600 E HOWELL ST RECOMMENDATION MEETING

600 E HOWELL ST
SDCI# 3024635

Construct 7-story mixed-use building, containing 76 residential units (67 SEDUs, 3 EDUs, 6 dwelling units) and 1,226 NSF of commercial space (restaurant use). Proposal to achieve Built Green 4-star certification with affordable housing incentives.

EDG PERSPECTIVES: SCHEME C: NARROW + ARTICULATED (PREFERRED)

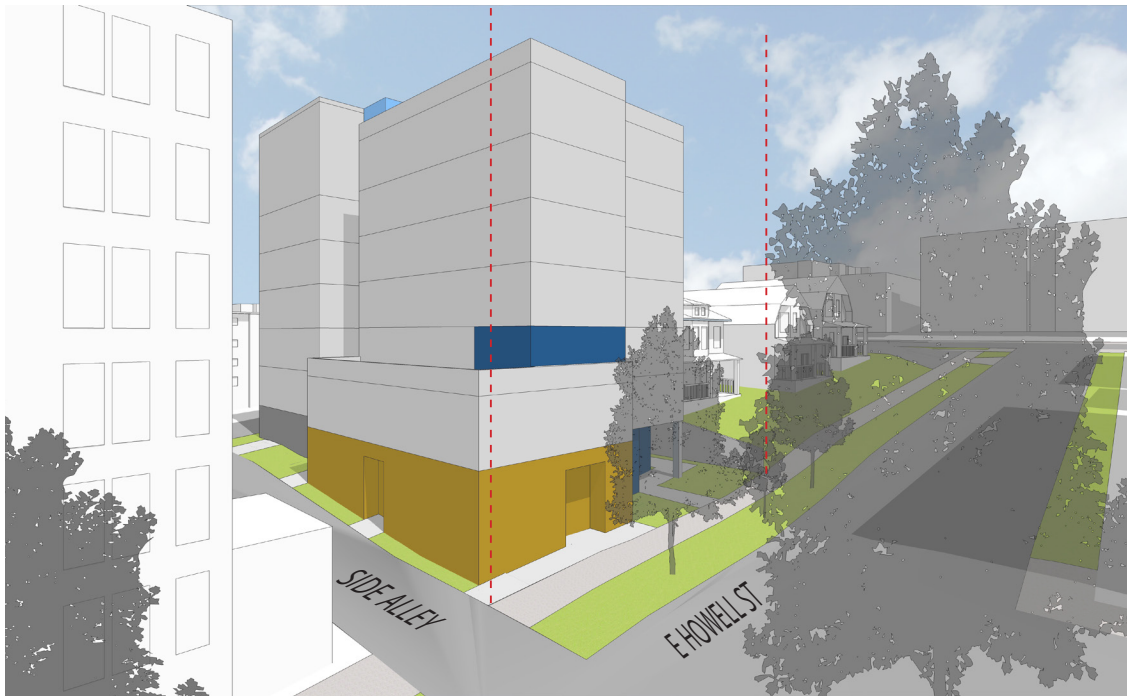
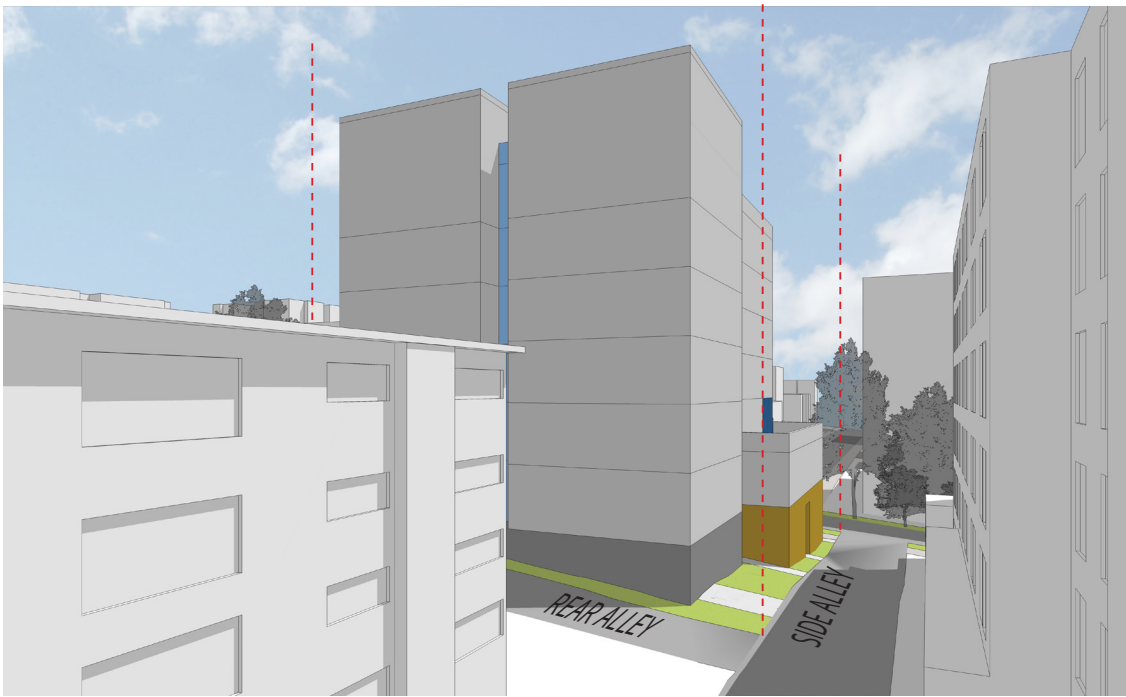
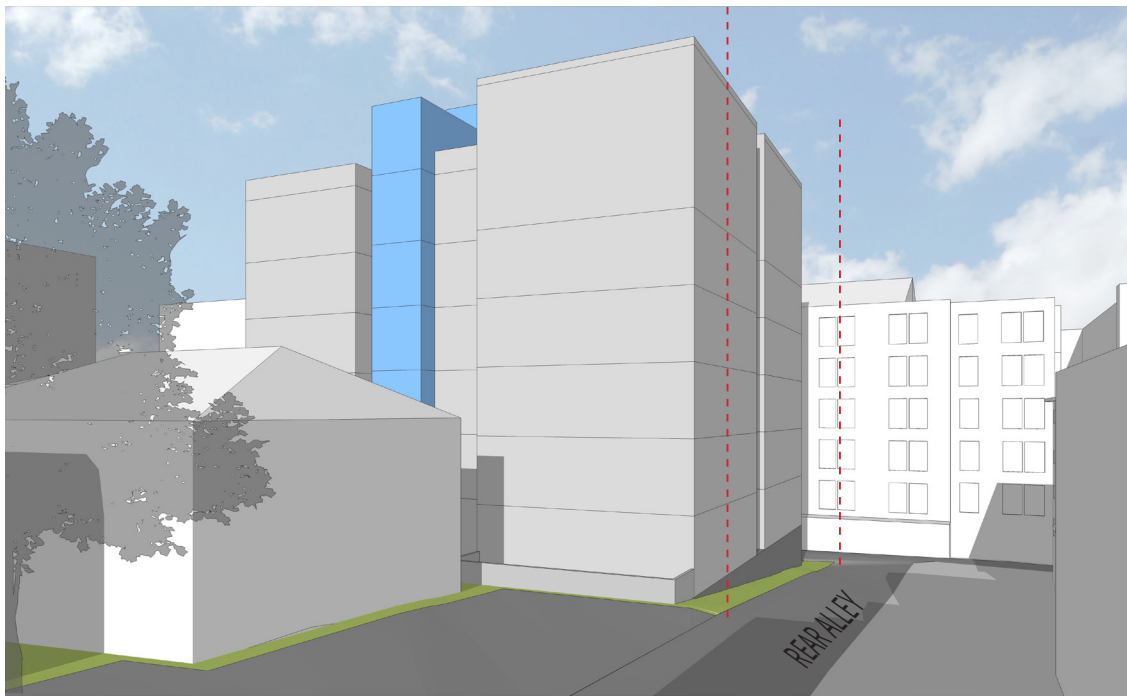
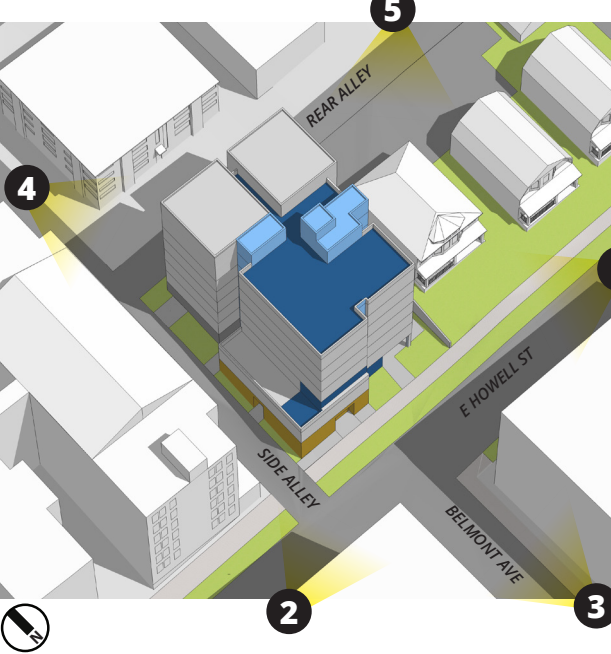
- Massing is an appropriate response to the surrounding context, site topography and function as both a mid-block and corner site.
- Strong support for location and transparency of the commercial 'box' as it reestablishes the commercial corner at the alley edge and use at the E. Howell Street.
- Supported arrangement of uses as seen from axial view along Belmont Avenue.
- Supported eroding the southeast building corner at the residential entry.
- Supported location of service functions along the west alley.

DEPARTURES: PROPOSED

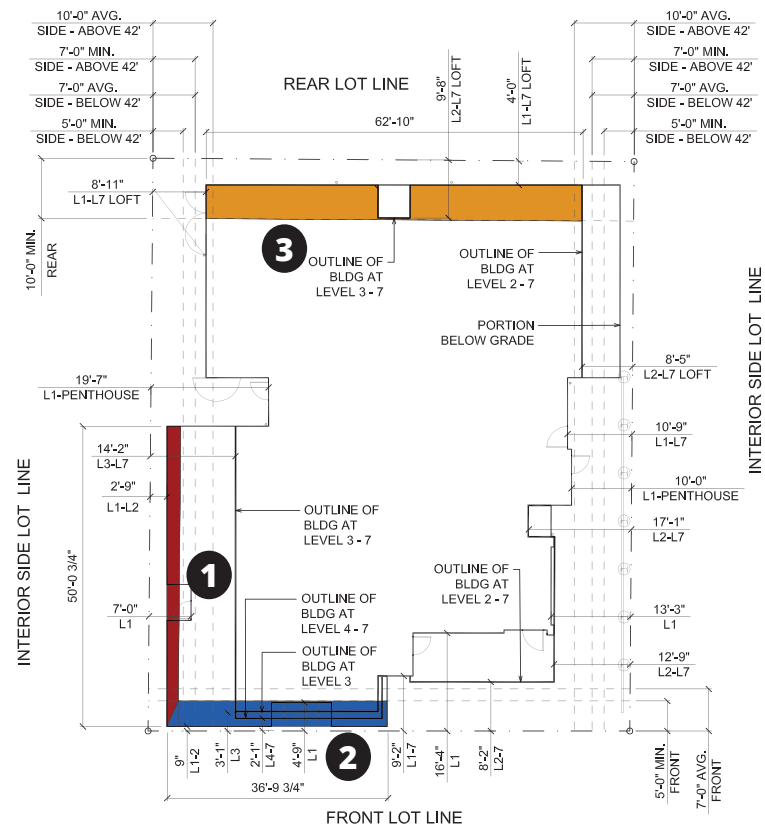
*The Board indicated support for this departure request as the design reestablishes the commercial corner at the alley edge and emphasizes the axial relationship to Belmont Avenue view. In addition, the setback emphasizes the modular expression of the massing. (CS2-B2, CS2-C1, DC2-B1)

*The Board indicated support for this departure request as the design reestablishes the commercial use at the street, enforces the axial response of the design to Belmont Avenue view, and is consistent with surrounding development patterns. (CS2-II.ii, CS2-C1, DC2-B2)

*The Board indicated support for this departure request, as the increased rear setback allows the building to shift towards the alley and provide additional space on the front elevation. (CS2-B2, CS2-D5)

JUSTIFICATION:
The proposed side setback re-establishes the commercial corner at the sidewalk edge, responds to pedestrian scale and provides separation from adjacent residential uses.

JUSTIFICATION:
The proposed reduced front setback is consistent with other 7-story buildings in the immediate vicinity. The proposed setback re-establishes a pedestrian scaled commercial corner, and creates a balanced composition visible from multiple viewpoints including Belmont Ave. The proposed minimum setback only occurs at the commercial corner.

JUSTIFICATION:
The proposed rear setback provides the opportunity for greater articulation along the east and west facades, and a more narrow footprint towards the rear of the site. The resulting massing responds to the rising topography, and provides additional separation to the east and west neighbors.
